Attachment 1
NRC3-12-0003

Table of RAI Response Dates
(5 pages)

Response to RAI Letter No. 70
(eRAI Tracking No. 6217)

RAI Question No. 02.05.02-17

Figure 8: Comparison of mean of response spectra (5 percent damping) for weakly matched time histories to the target DE spectra for the 10^{-6} low frequency (LF) motions

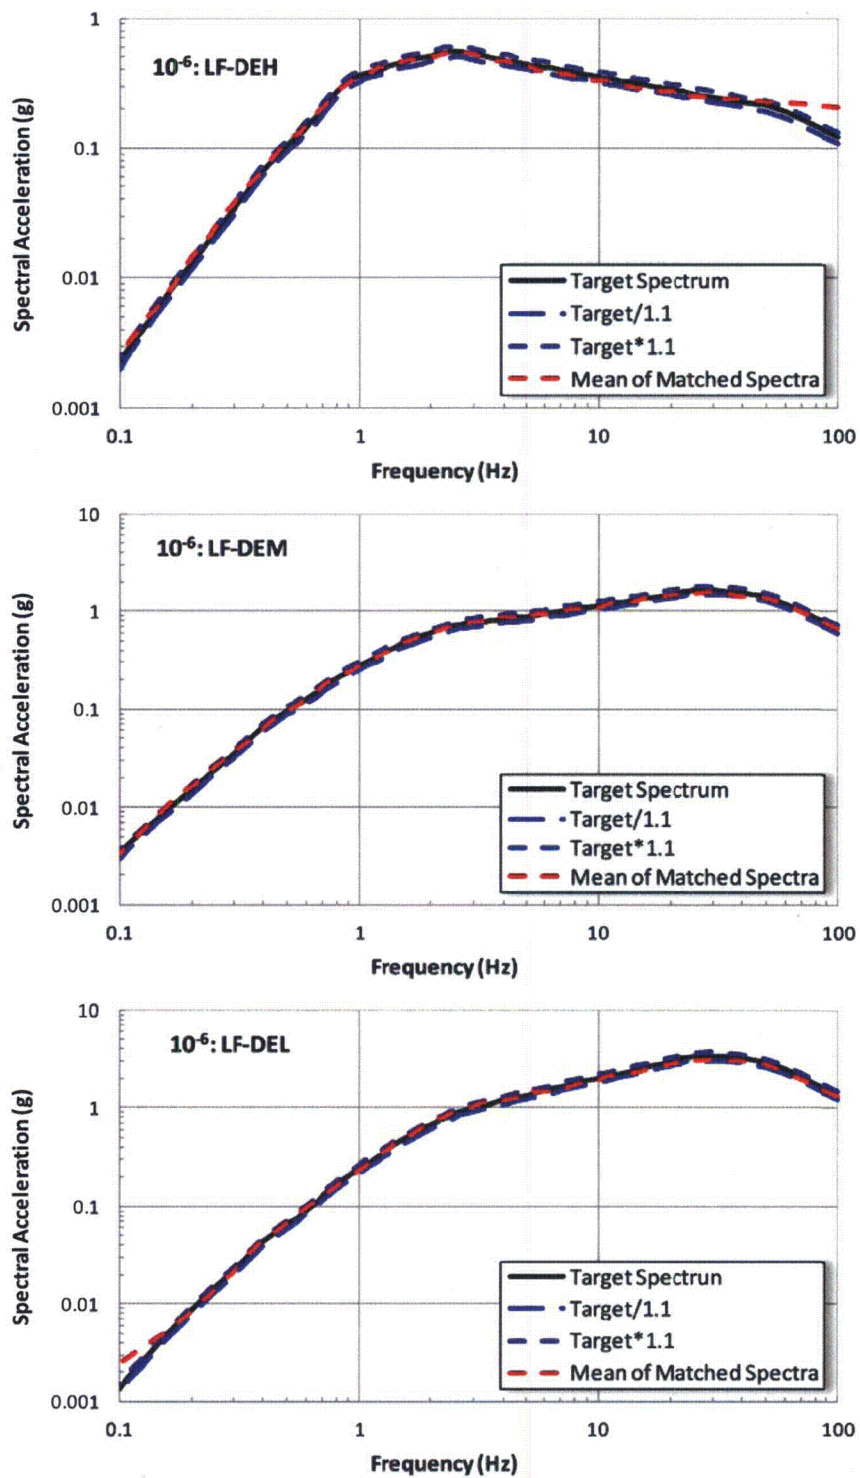
FSAR Section 2.5.2.5.2 indicates that the selected time histories were scaled to approximately match the target DE spectrum using a limited number of iterations of the program RASCALS. Please provide more detail regarding the scaling process. In addition, please quantitatively compare the mean response spectrum of each suite of scaled time histories to the respective target spectrum.

DE target response spectra were developed to represent the contributions to the Fermi 3 site hazard for high frequency (HF) and low frequency (LF) ground motions. DE spectra were developed for hazard levels corresponding to 10^{-3} , 10^{-4} , 10^{-5} , and 10^{-6} mean annual frequencies of exceedance. The target magnitudes and distances for each DE are listed in FSAR Table 2.5.2-219. For each case, three DE spectra are defined: a high magnitude target, DEH; an intermediate magnitude target, DEM; and a low magnitude target, DEL. As described in FSAR Subsection 2.5.2.5.2, the 30 time histories in the appropriate magnitude and distance bin of the central and eastern United States (CEUS) time history database in NUREG/CR-6728 (McGuire et al., 2001) were weakly matched to each DE spectrum. Figures 1 through 8 compare the target DE spectra to the mean response spectra for the 30 scaled time histories for HF and LF motions at the four hazard levels. Each plot also shows the target DE spectrum multiplied by 1.1 and divided by 1.1 to provide a sense of the accuracy of the average fit.

The comparisons shown on Figures 1 through 8 show that the means of the response spectral ordinates for the scaled time histories are generally within a factor of 1.1 of the target DE response spectrum. All spectra shown on the figures are for 5 percent damping. In some cases, large deviations from the target spectrum occur at frequencies below about 0.2 Hz. Because the fundamental frequencies of the site profiles are approximately 3 Hz, the deviations at very low frequencies have little impact, as indicated by the amplification factors near unity for frequencies less than 1 Hz (e.g., FSAR Figure 2.5.2-270). In a few cases for the LF DE spectra (LF DEH for 10^{-5} and 10^{-6}), large deviations from the target spectrum occur at frequencies above 50 Hz. These deviations are not significant because the motions in this frequency range are not used to define the LF site amplification factors.

The results shown on Figures 1 through 8 indicate that the mean of the response spectra for the weakly scaled time histories provide a good representation of the DE target response spectra.

Figure 3.7.1-228: Fermi 3 Horizontal RB/FB SCOR FIRS and Enhanced SCOR FIRS (5% Damping).

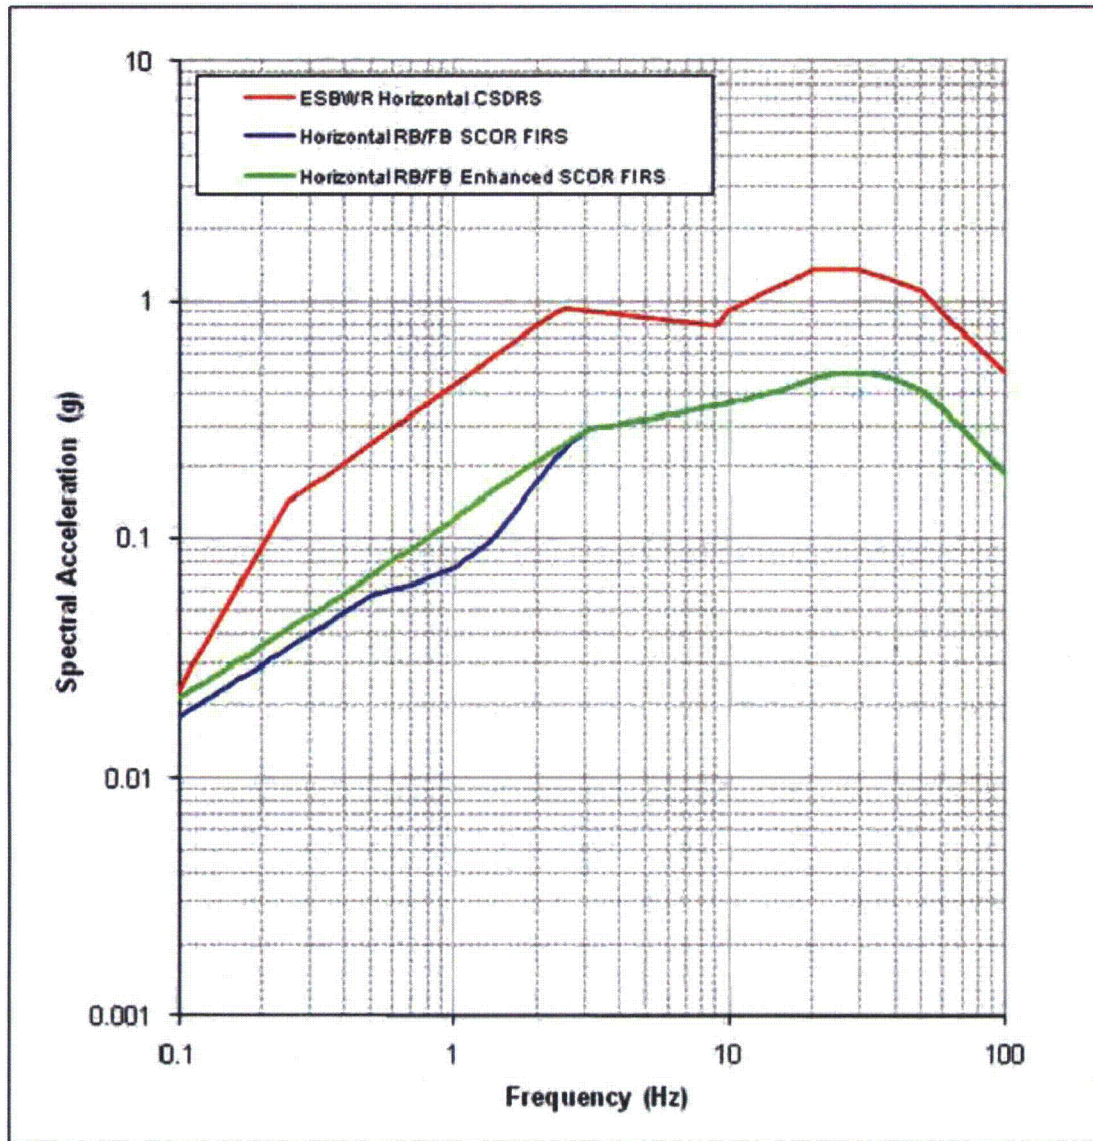
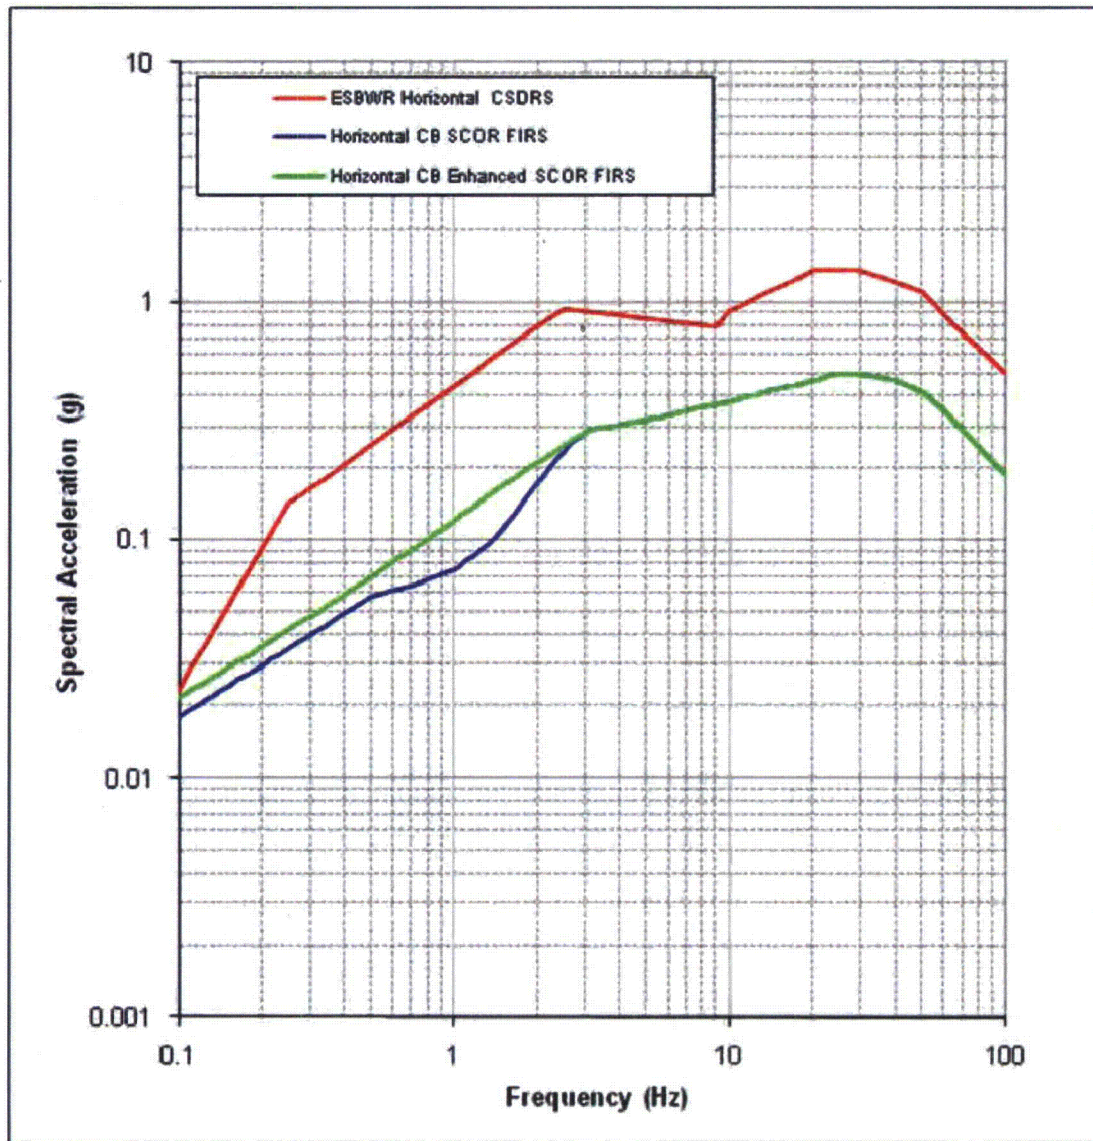
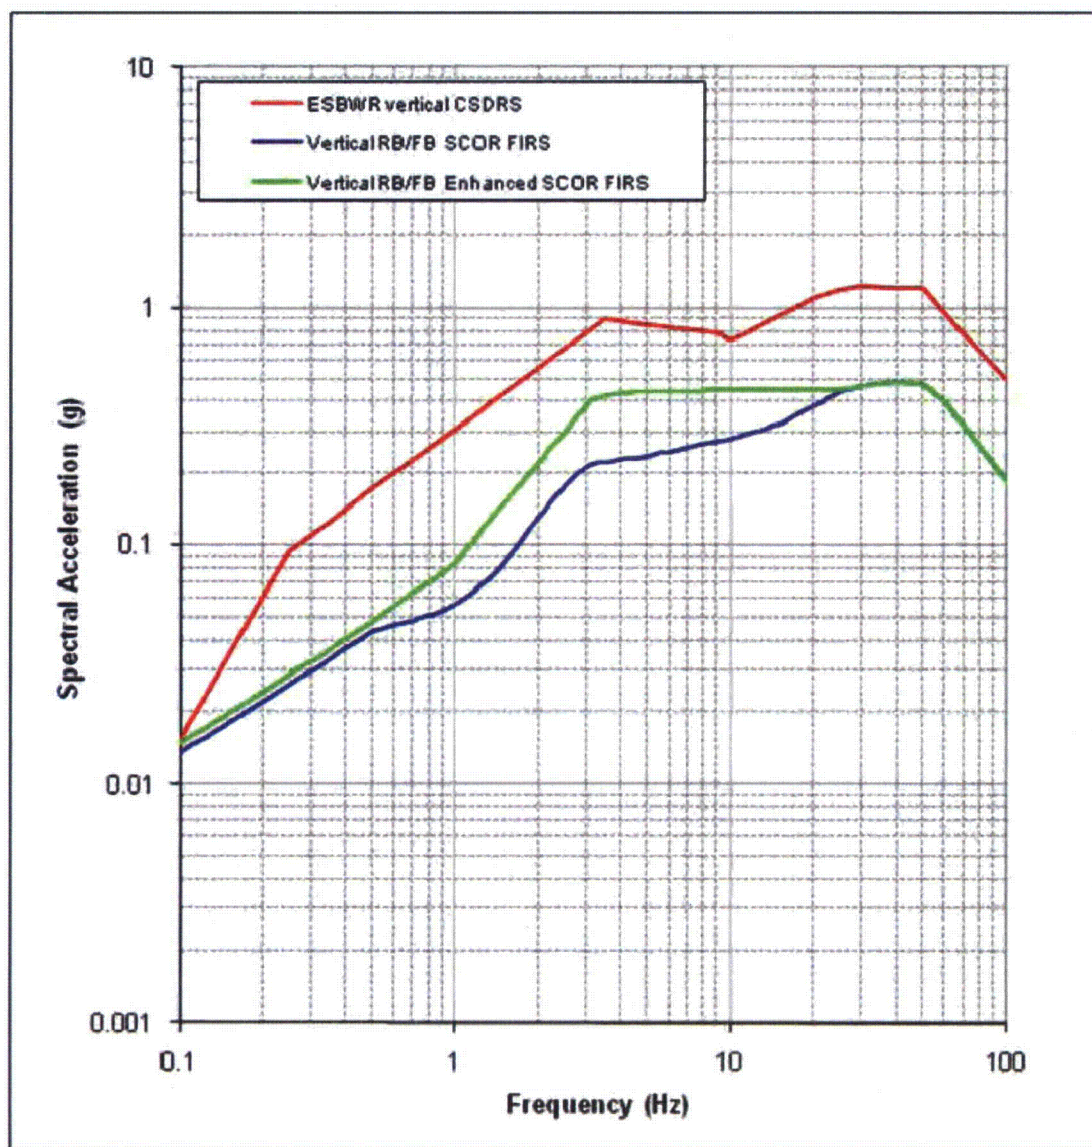
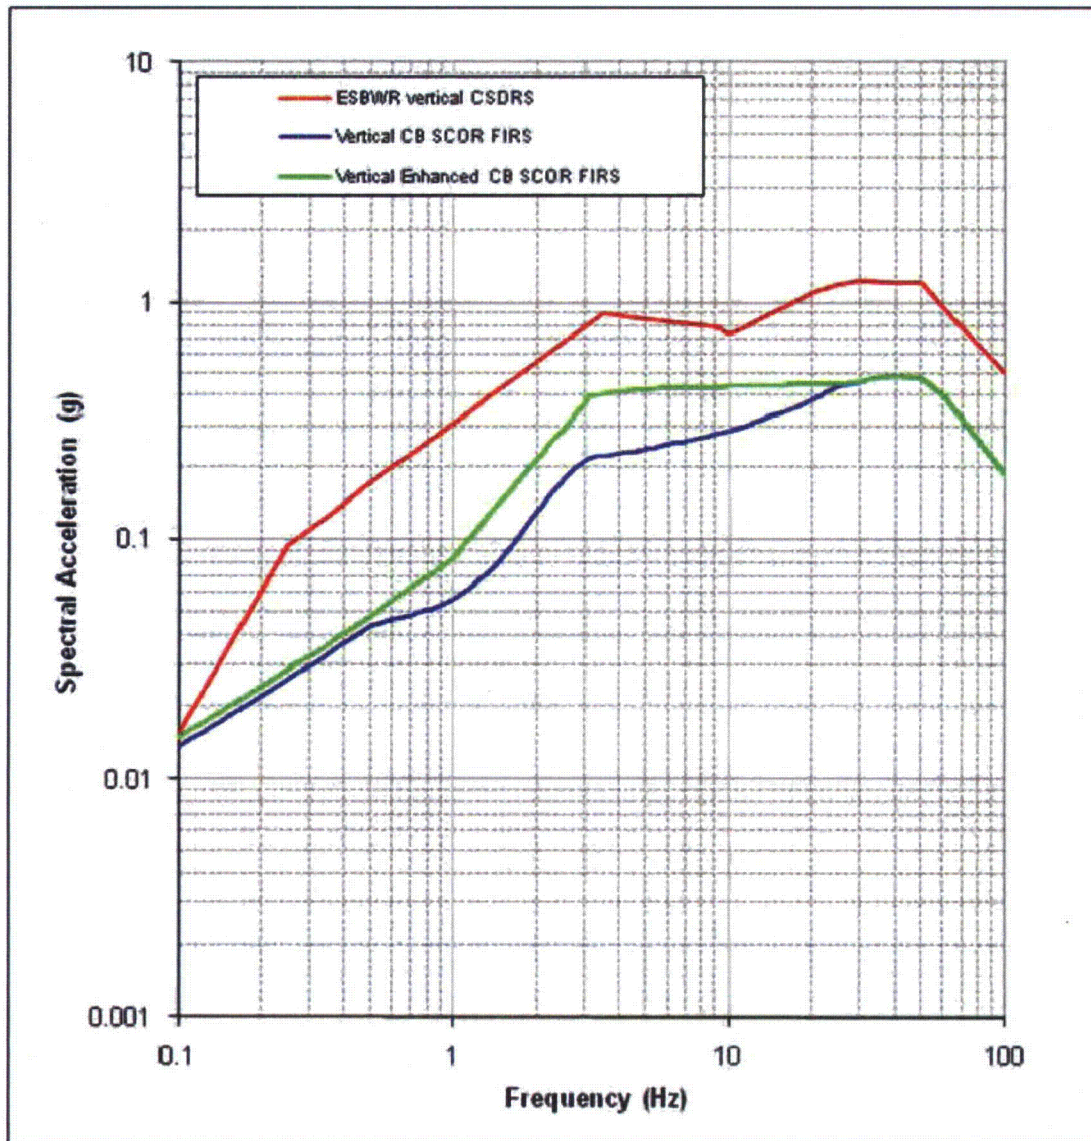
Based on the above discussion, the staff needs additional technical basis for using two components of ground motion with correlation coefficient of approximately 0.30. If Regulatory Position C.2.2(2) of RG 1.92 is used for determining the total site-specific seismic demand for the SSCs, the applicant is requested to provide a comparison with the seismic demand as determined from the use of Regulatory Position C.2.2(1), and demonstrate that the current site-specific seismic demand as specified in EF3 FSAR is not under predicted.

The horizontal SCOR FIRS were then enhanced by increasing the overall level of ground motion in the frequency ranges identified during the comparison of the resulting envelope of the three surface spectra from the time histories and the PBSRS. Figure 3.7.1-228 and Figure 3.7.1-229 show the horizontal SCOR FIRS and the horizontal enhanced SCOR FIRS for the RB/FB and CB, respectively. Also shown on Figure 3.7.1-228 and Figure 3.7.1-229 are the horizontal ESBWR CSDRS (Reference 2.5.2-291). The enhanced horizontal SCOR FIRS for the RB/FB and CB are enveloped by the horizontal ESBWR CSDRS. Time histories matched to the enhanced SCOR FIRS were then convolved from the foundation level up to the finished ground level grade using the full soil column LB, BE, and UB subsurface profiles for comparison to the PBSRS at the finished ground level grade. Figure 3.7.1-230 to Figure 3.7.1-231 show the comparison of the PBSRS at the finished ground level grade with the envelope of the surface response spectra obtained from SHAKE analyses using the LB, BE, and UB full soil column profiles and the matched time histories compatible with the RB/FB and CB enhanced SCOR FIRS, respectively. The envelope of the three response spectra at the ground surface exceeds the PBSRS at the finished ground level grade for each component of motion, satisfying the Interim Staff Guidance DC/COL-ISG-017 and the NEI developed white paper (Reference 3.7.1-206). The RB/FB and CB enhanced horizontal SCOR FIRS values are provided in Table 3.7.1-210 and Table 3.7.1-211, respectively.

The vertical SCOR FIRS was also enhanced in the identified frequency ranges. Figure 3.7.1-232 and Figure 3.7.1-233 show the vertical SCOR FIRS and the vertical enhanced SCOR FIRS for the RB/FB and CB, respectively. Also shown on Figure 3.7.1-232 and Figure 3.7.1-233 are the vertical ESBWR CSDRS (Reference 2.5.2-291). The enhanced vertical SCOR FIRS for the RB/FB and CB are enveloped by the vertical ESBWR CSDRS. Vertical component time histories matched to the enhanced SCOR FIRS were then convolved from the foundation level up to the finished ground level grade using the full soil column LB, BE, and UB subsurface profiles for comparison to the PBSRS at the finished ground level grade. Figure 3.7.1-234 to Figure 3.7.1-235 show the comparison of the PBSRS at the finished ground level grade with the envelope of the surface response spectra obtained from SHAKE analyses using the LB, BE, and UB full soil column profiles and the matched time histories compatible with the RB/FB and CB enhanced SCOR FIRS. The envelope of the three response spectra at the ground surface exceeds the PBSRS at the finished ground level grade for each component of motion, satisfying the Interim Staff Guidance DC/COL-ISG-017 and the NEI developed white paper (Reference 3.7.1-206). The RB/FB and CB enhanced vertical SCOR FIRS values are provided in Table 3.7.1-210 and Table 3.7.1-211, respectively.
